QUALITY ASSURANCE -- NON-CONFORMANCE REPORT

Location: Changxing Island, Shanghai, P.R. China**Report No:** NCR-000917**Prime Contractor:** American Bridge/Fluor Enterprises, a JV**Date:** 23-Nov-2010**Submitting Contractor:** Zhenhua Port Machinery Company, Ltd (ZPMC), Changxing Island**NCR #:** ZPMC-0879**Type of problem:**

Dear: Mr. Charles Kanapicki
Attention: Mr. Thomas Nilsson Project/Fabrication Manager
Subject: NCR No. ZPMC-0879

Job Name: SAS Superstructure
Document No: 05.03.06-000874

The weld is identified as BK004A6-062-106/107

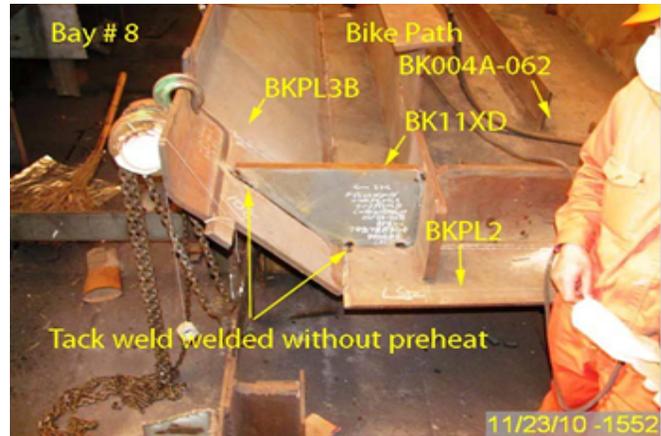
ZPMC welding personnel did not follow the "Weld Procedure Requirements for New Welds" by Rager/McQuaid

- 2e) Assembly: All tack welding shall be performed in accordance with an approved WPS and as amended by this procedure.
- 2f) Assembly: Preheat shall be applied in such a manner to provide a minimum temperature in the area of the weld of 165°C.

The welding process used was Shielded Metal Arc Welding (SMAW)

The weld is a Fillet weld joining Side Plate BKPL3B to Bearing Plate BKX11D.

CT acknowledges contractor's response. However, successful NDT will close this NCR.

Normal NCR closure package with NDT reports shall be submitted with the NPR to close out the NCR.

This proposed resolution is acceptable. The documentation received is sufficient and the Department concurs that Non-Conformance ZPMC-0879 is closed.

The weld is identified as BK004A6-062-106/107

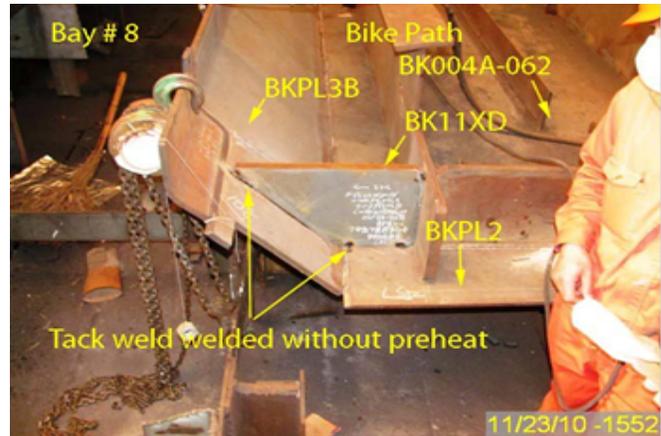
ZPMC welding personnel did not follow the "Weld Procedure Requirements for New Welds" by Rager/McQuaid

-2e) Assembly: All tack welding shall be performed in accordance with an approved WPS and as amended by this procedure.

-2f) Assembly: Preheat shall be applied in such a manner to provide a minimum temperature in the area of the weld of 165°C.

The welding process used was Shielded Metal Arc Welding (SMAW)

The weld is a Fillet weld joining Side Plate BKPL3B to Bearing Plate BKX11D.

Contractor provided the NDT report. The report shows the weld is acceptable.
